<b>Docket Number:</b>	17-BSTD-01
<b>Project Title:</b>	2019 Building Energy Efficiency Standards PreRulemaking
<b>TN #:</b>	217464
<b>Document Title:</b>	Tesla Comments - 2019 ZNE Residential Standards Apr 20 Workshop
<b>Description:</b>	N/A
<b>Filer:</b>	System
<b>Organization:</b>	Francesca Wahl
<b>Submitter Role:</b>	Other Interested Person
<b>Submission Date:</b>	5/5/2017 4:38:04 PM
<b>Docketed Date:</b>	5/5/2017

**Tesla Comments - 2019 ZNE Residential Standards Apr 20 Workshop**

RE: April 20, 2017 Staff Workshop 2019 Zero Net Energy Residential Standards

#### EDR Credit Value

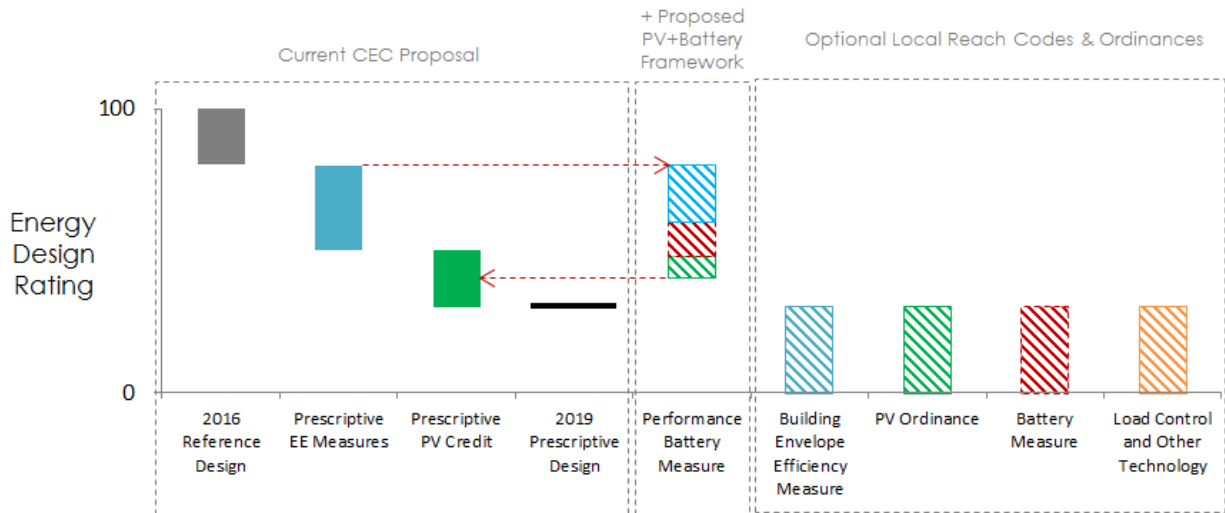
For the EDR tradeoff credit value for storage, we recommend analyzing two potential options: 1) solar plus storage and 2) stand-alone storage. Under the performance based approach, a builder should have the flexibility to include both solar and storage to meet grid efficiency and cost effectiveness standards and obtain an acceptable EDR target as determined by the CBECC-Res software. One mechanism to do this is to provide a tradeoff credit for solar plus storage above the 2016

standard energy efficiency requirements. The illustrative example below demonstrates how battery storage is used as a performance measure in conjunction with other efficiency measures to meet the efficiency portion of the EDR calculation while PV is added separately to reach the overall 2019 EDR value.

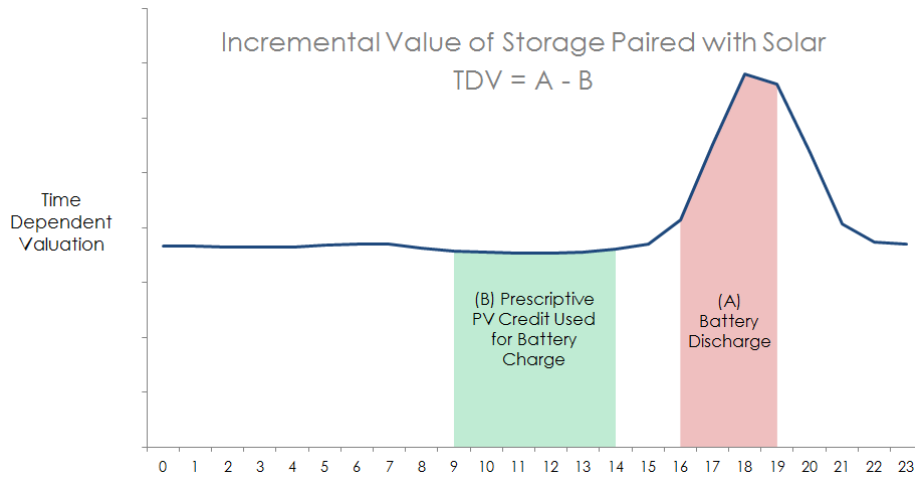
When determining the actual TDV and EDR value of battery storage, it is important to distinguish the solar PV kilowatt (kW) array size compared to the prescriptive design measures. In the standard design, PV is eligible for a certain amount of credit that we can assume is installed regardless of battery storage. When CEC staff discussed the opportunities for pairing solar with storage during the workshop, it was suggested that solar plus storage would reduce the prescriptive PV kW size requirements since solar plus storage is more effective at reducing TDV and thus can achieve the same PV credit with fewer kilowatts of solar. In this scenario, if a reduced amount of solar is in fact installed then the incremental value of the battery is the difference between the time in which the battery was charged by solar and when the battery was discharged during high TDV periods. Below is an illustrative example of the incremental value of storage on an average TDV basis in this scenario.

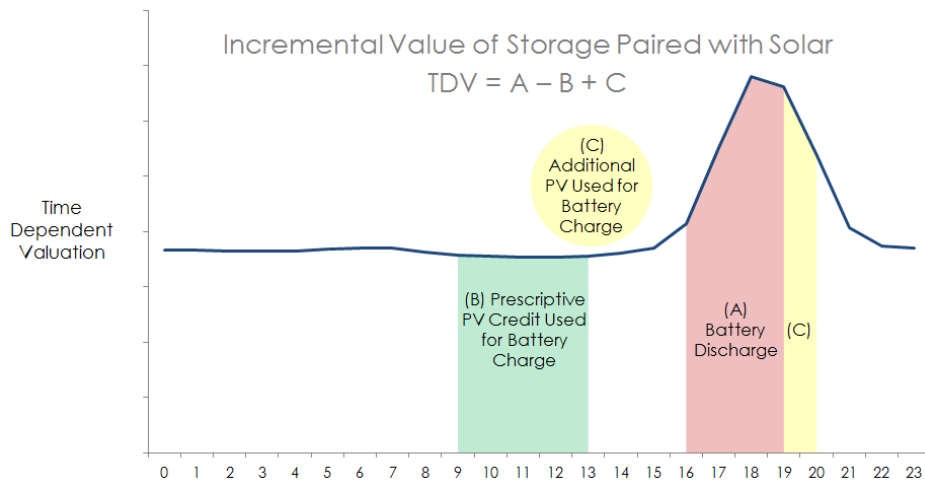
In another scenario a larger PV kW array size may be installed beyond the reduced PV with storage prescriptive amount in order to fully utilize the battery storage. In these cases, the additional PV installed with storage should be valued at an incrementally higher amount since the additional PV would not have otherwise been installed and is not eligible for the prescriptive PV credit. For example, if the standalone PV prescriptive size is 6 kW, the current approach proposed by the CEC staff may only provide a PV credit for 3 kW when combined with battery storage. Our proposal is that if 6 kW are in fact installed, the additional 3 kW beyond the prescriptive amount should be credited at the full TDV value under the performance battery measure. An illustrative example of this scenario is shown below.

In cases where the additional PV is providing TDV and EDR value, the total PV must not be sized to greater than the battery capacity. This scenario also assumes the battery to be 100% charged from on-site solar. This is supported by the fact that currently under interconnection requirements for net energy metering (NEM) solar plus storage customers, the customer has the option to attest that the battery is not charged using the interconnecting utilities' distribution system by checking a box in the interconnection agreement.<sup>8</sup> Additionally, the total PV generation should not exceed the total on-site electricity kWh consumption to avoid any conflict with customer net metering rules.
